Proposal for corrections to UN Regulations Nos. 113 and 149

I. Proposal

“Figure C

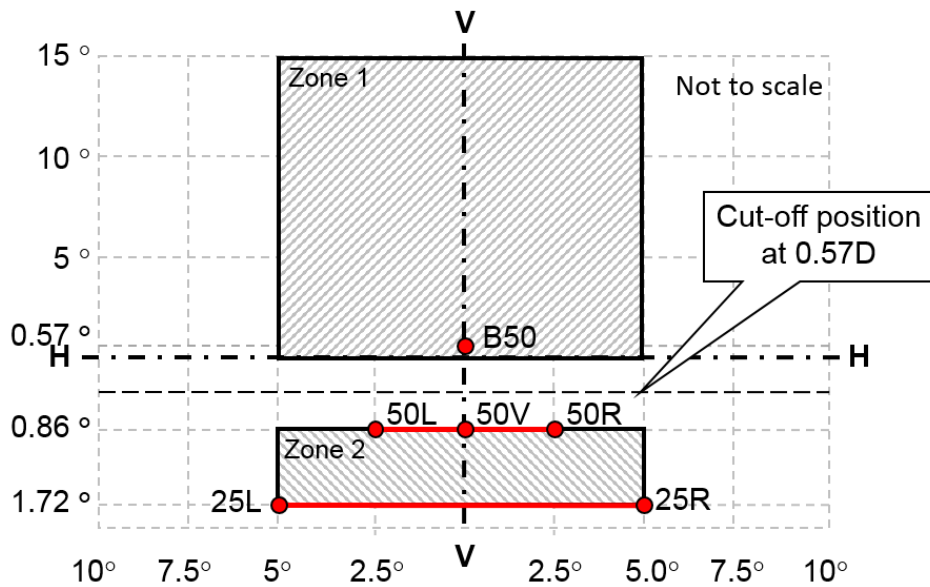
Annex 3, Figure C; amend to read:

1. This proposal to amend UN Regulation No. 113 corrects a mistake introduced by the 01 series of amendments to UN Regulation No. 113 when angular coordinates were introduced instead of dimensions in mm with screen at 25m.
2. The same correction applies to the 02 and 03 series of amendments to UN Regulation No. 113 as well as to UN Regulation No. 149.
3. In UN Regulation No. 113, Annex 3, Figure C, the description of the zone 1 is not in line with the photometric requirements set in paragraph 6.2.5.2. which defines the horizontal angles to 5° to the left and 5° to the right.
4. In UN Regulation No. 149, Annex 4, Figure A4-IX, the description of the zone 1 is not in line with the photometric requirements set in paragraph 5.4.4.2. Table 34 which defines the horizontal angles to 5° to the left and 5° to the right for the class BS headlamps.

“Figure C

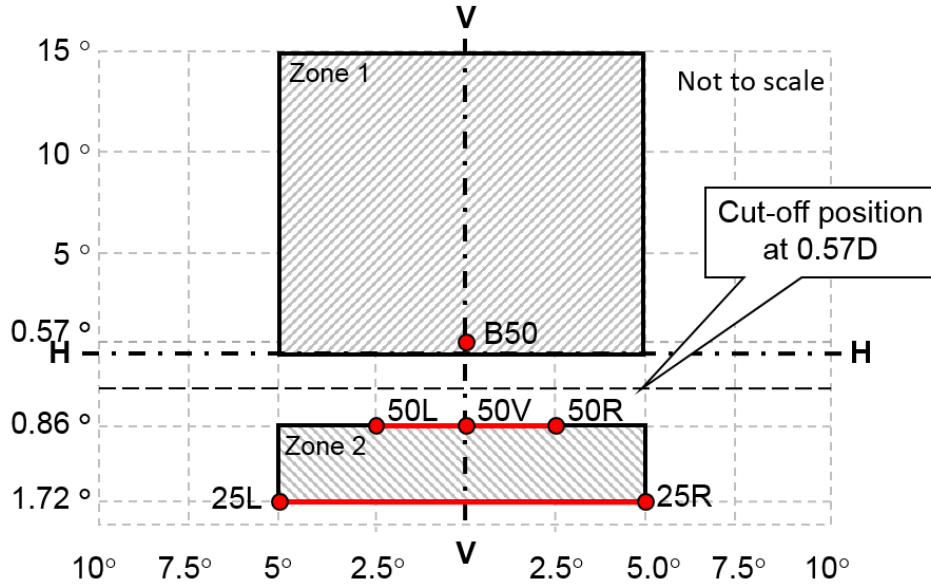
Annex 3, Figure C; amend to read:

“Figure C

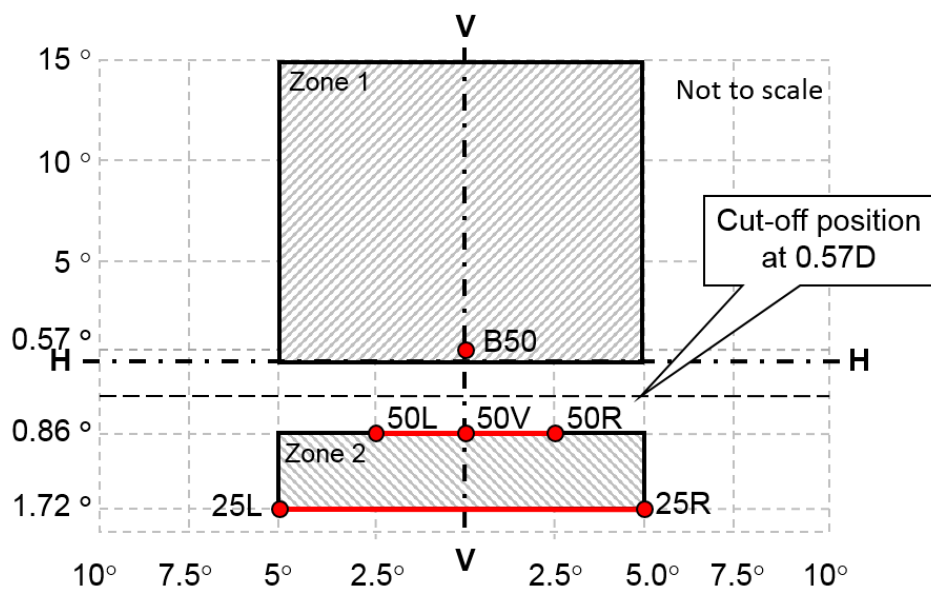
Annex 3, Figure C; amend to read:

“Figure A4-IX

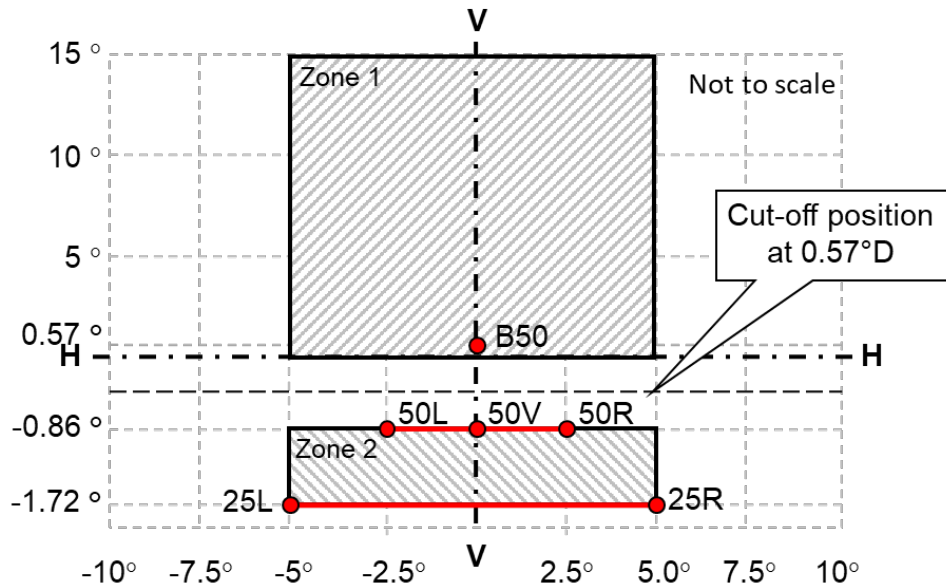
Annex 4, Figure A4-IX; amend to read:
